City of Salmon Arm Development and Planning Services Committee

Monday, July 6, 2020
8:00 a.m.
Council Chambers, City Hall
500 – 2 Avenue NE

Subject: Zoning Bylaw Amendment Application No. 1177

Subject: Development Permit Application No. DP-427 (Multi-Family Residential)
 Legal: Lot B, Section 13, Township 20, Range 10, W6M, KDYD, Plan KAP70506
 Civic: 1351 10 Avenue NE
 Owner/Applicant: Habitat for Humanity / GTA Architecture Ltd.

COVER PAGE

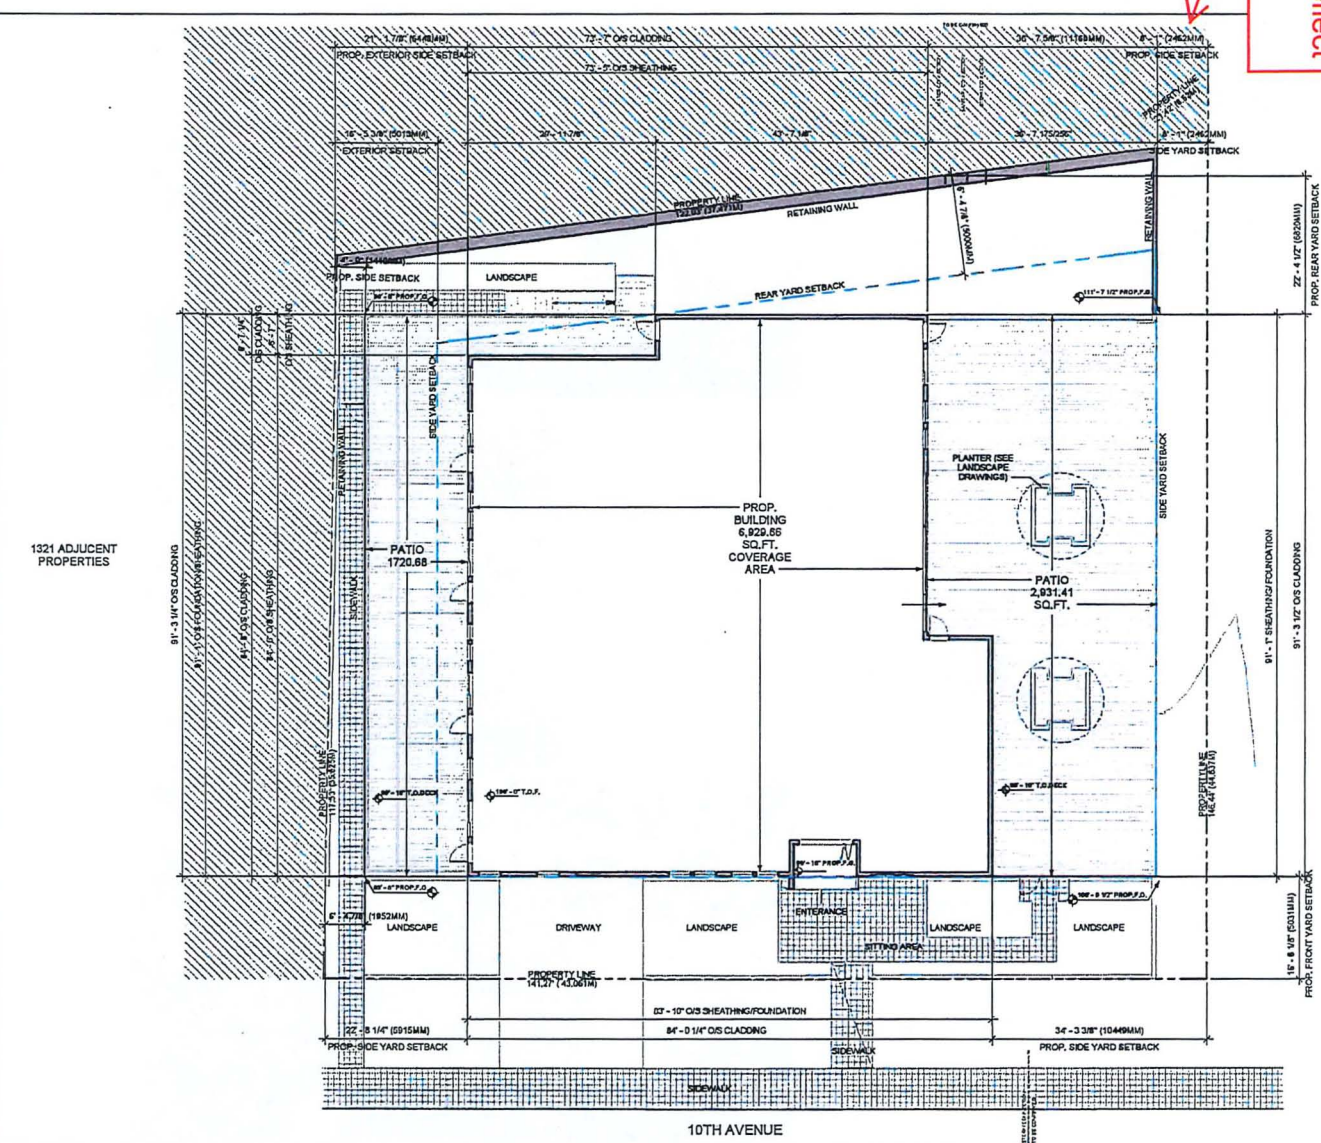
Setback to be increased
~55 cm to reflect
easement

CONCEPTUAL LANDSCAPE PLAN

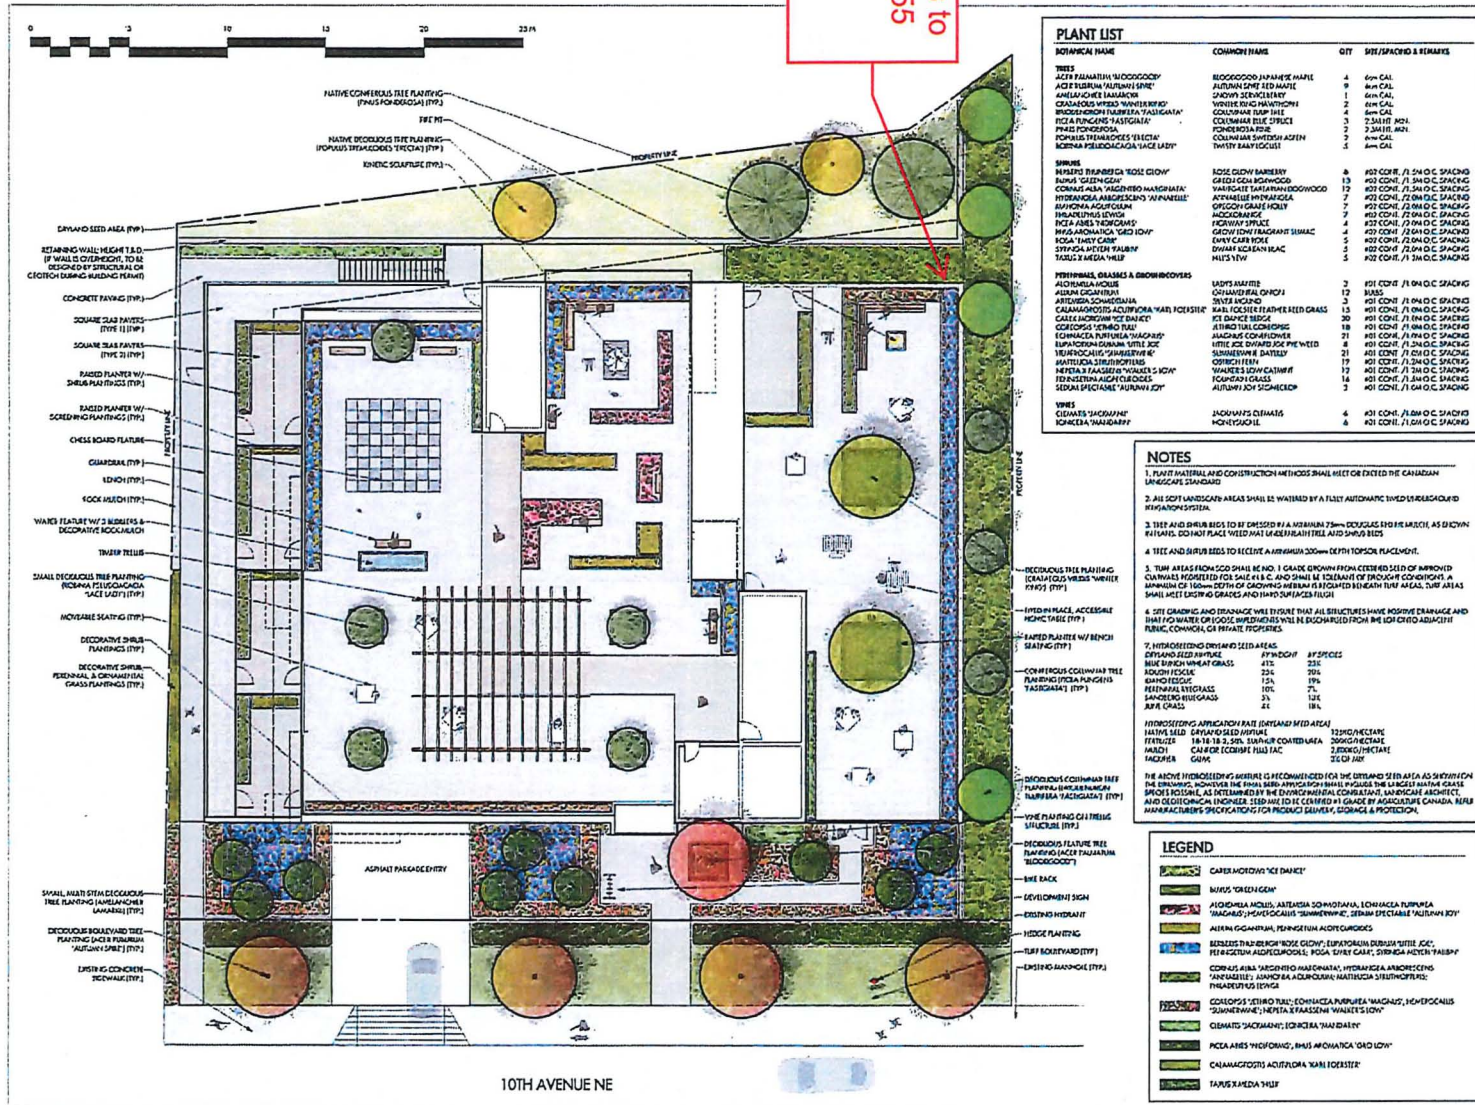
Building mass to be reduced ~55 cm to reflect easement
